NUMBER: 22-005-01

GROUP: Wheels/Tires

Wheel Cover Rattle - 15" Steel Wheels

2000 - 2001 (PL) Neon

Fig. 1 WHEEL COVER

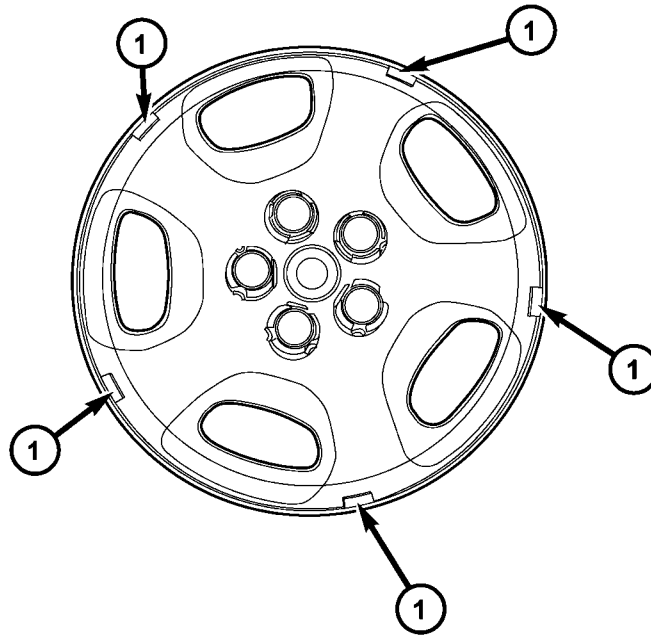
This bulletin involves the addition of 5 foam pads to each wheel cover.

Rattle noise coming from the wheel cover over bumps.

1. Clean the inside surface of the wheel cover where the foam pad will be installed using the Mopar Brake Parts Cleaner.
2. Wipe the cleaner off and allow the wheel cover to dry thoroughly.
3. Remove the backing paper from a foam pad and apply to in the center of one wheel spoke. Repeat the process until all five foam pads have been installed. (Fig. 1)
4. Repeat the procedure for the remaining three wheel covers.
5. Install the four wheel covers onto the vehicle and torque nuts to 25 in.lbs.

1 - FOAM PADS
